Field Safety Notice

Regarding wing handles for ReTurn 7400 and 7500

Fig 3 New, safer model of wing handle. The thread runs into the handle.

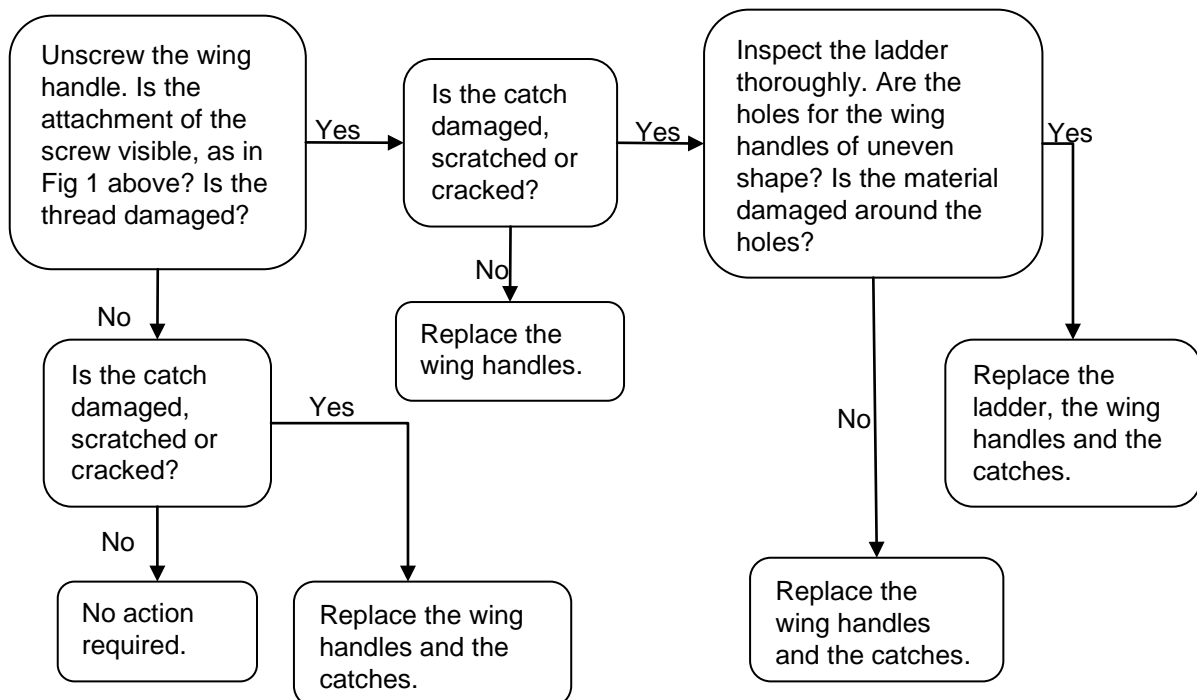
Wing handles for ReTurn7400 and ReTurn7500, where the **screws are not properly inserted into the handles**, marked in red in figure 1. This affects **only ReTurn models where the ladder is attached to the chassis according to figure 2**. All ReTurn7400 and ReTurn7500 of this design, delivered until May 2011 may feature the affected wing handle. The spare part "Wing handles", article number 7322, delivered during the period June 2009 to July 2011 is also affected.

During the period April 2009 to May 2011, Handicare AB used a wing handle in which the screw and the handle, after repeated tightening, may slide apart. This causes a small play in the attachment of the ladder, which in turn results in high load at the attachment holes of the ladder. Eventually this may cause mechanical fatigue in the material of the ladder.

Since Handicare changed suppliers of the wing handle in May 2011, the wing handle has a design that keeps the screw safely in the handle, fig. 3, and thereby keeps the catch close to the ladder, minimising the risk of play.

As a measure of precaution, Handicare has decided to replace all wing handles where the attachment of the screw is visible.

A check of all ReTurn subject to having the affected wing handle should be performed without any delay. Inspect all devices in service and in warehouses. Remove and scrap all affected components.
